STAFF REPORT

RE: Stone Prairie Plat 4 – Preliminary Plat, Final Plat,
& Site Plan

DATE: October 25, 2016

ABOVE: Proposed development outlined in red dashed line. The proposed dental clinic is on Lot 1 (red building) and proposed Lot 2 is the yellow area to the north.

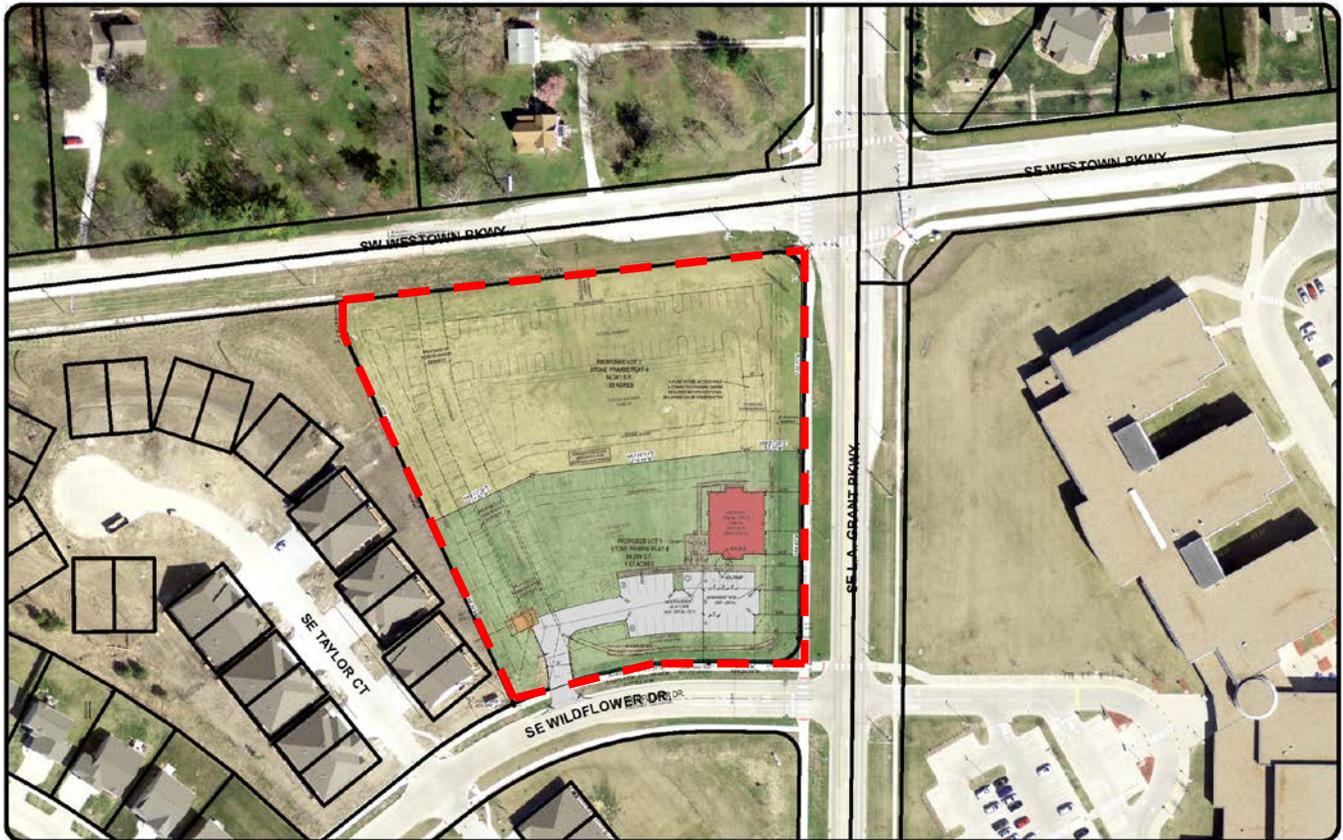
The proposed dental clinic will be accessed off of SE Wildflower Drive on the west side of Lot 1. Future site plans will require that the connection to SE Westtown Parkway be provided regardless if future development occurs on Lot 1 or Lot 2.

No public sidewalks are required as part of this initial development. However, future site plans for any additional improvements on the site will require that the public improvements along SE Westtown Parkway be completed. These improvements will include storm sewer, curb and gutter, and a 5 foot sidewalk. There is an existing 10 foot trail that is located on the north side of SE Wildflower Drive that will provide pedestrian access to the site.

Storm water detention will be provided in a detention pond that is proposed to be located on the south side of the proposed dental clinic. The pond will outlet to the storm sewer along SE Wildflower Drive which connects to a 42-inch storm sewer on the east side of SE L.A. Grant Parkway. The storm water will then be routed to the south to its ultimate discharge point.

The required amount of open space for the development is 20% and the applicant will provide 75 % open space. The required amount of landscaping has been provided. In addition, landscape buffers will be provided on the east, south, and west sides of the development.

The trash enclosure for the proposed development is provided on the west side of the access drive.

At this time staff is comfortable with the site plan and would recommend approval of the preliminary plat, final plat, and site plan for Stone Prairie Plat 4 subject to remaining staff comments.
